**PLANNED UNIT DEVELOPMENT &
SUBDIVISION STAFF REPORT**

Date: February 17, 2005

<u>DEVELOPMENT NAME</u>	Rochester Place Subdivision, Revised Plat of
<u>DEVELOPMENT NAME</u> <u>SUBDIVISION NAME</u>	Rochester Place Subdivision, Revised Plat of
<u>LOCATION</u>	Northwest corner of Airport Boulevard and General Pershing Avenue (not open), extending North and West to the South side of South Sunset Drive
<u>CITY COUNCIL</u> <u>DISTRICT</u>	District 5
<u>PRESENT ZONING</u>	R-1, Single-Family Residential
<u>AREA OF PROPERTY</u>	
<u>CONTEMPLATED USE</u>	Amend the buffer (setback requirement) of a previously approved Planned Unit Development, private street, single-family residential subdivision.
<u>TIME SCHEDULE</u> <u>FOR DEVELOPMENT</u>	Immediate
<u>ENGINEERING</u> <u>COMMENTS</u>	Must comply with all stormwater and flood control ordinances. Any work performed in the right of way will require a right of way permit.
<u>TRAFFIC ENGINEERING</u> <u>COMMENTS</u>	Driveway number, sizes, location and design to be approved by Traffic Engineering and conform to AASHTO standards.

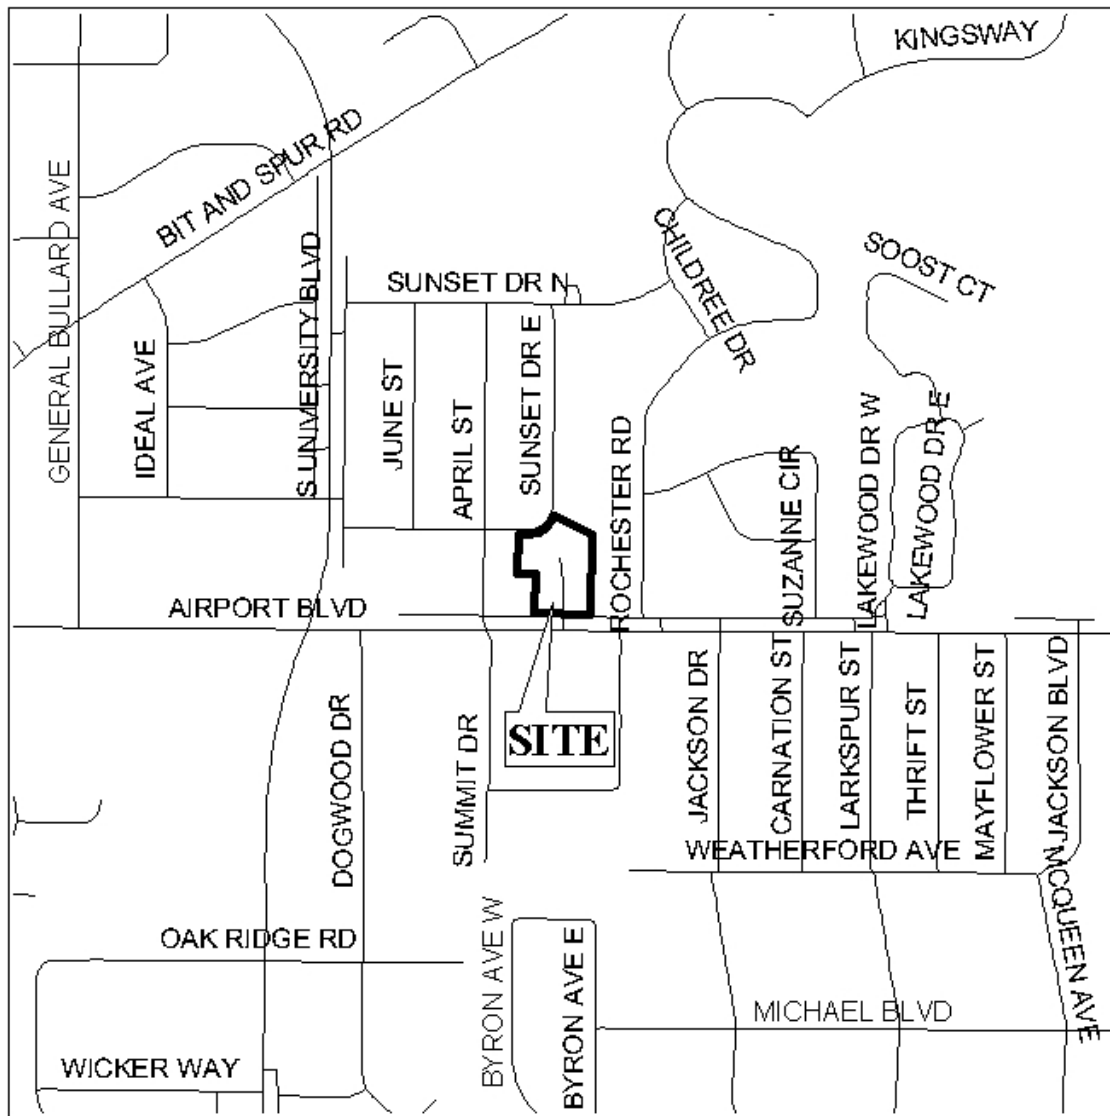
The rear of lots 7A-9A have frontage on both Rochester Place and South Sunset Drive. The previous application illustrated a 25-foot wide buffer and common area along South Sunset Drive. The applicant now proposes a 10-foot building setback along South Sunset Drive, and residential lots fronting two streets typically provide only an eight foot setback from the rear street property line. Additionally, buffers are rarely (if ever) required by the Commission to screen R-1 property from R-1 development. However, to restrict access to the private street, a note should be placed on the final plat stating that the site is denied direct access to Sunset Drive South.
